PROTERRA

TECHNICAL SERVICE BULLETIN

ISSUE DATE:	6-15-2021
SERVICE BULLETIN SUBJECT:	800 Volt ZX5 Horn Relay Retrofit
VINs or MODELS AFFECTED:	Service Specified Buses
COMPLETE BY:	Next Service Opportunity
SERVICE BULLETIN #:	SC-21-87
LABOR OPERATION CODE:	DE43Z

800 VOLT ZX5 HORN RELAY RETROFIT

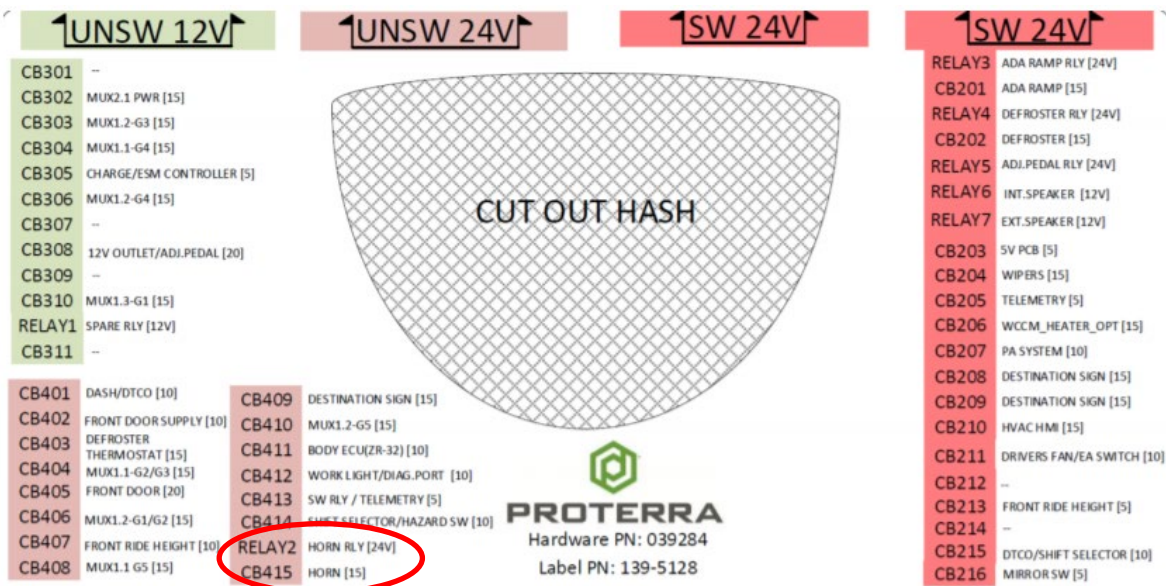
1. Complete the Proterra approved Lockout/Tagout procedure to make the bus safe for work.
2. Using a T-30 Torx Driver, remove the ECAB Panel as shown in the following photograph.
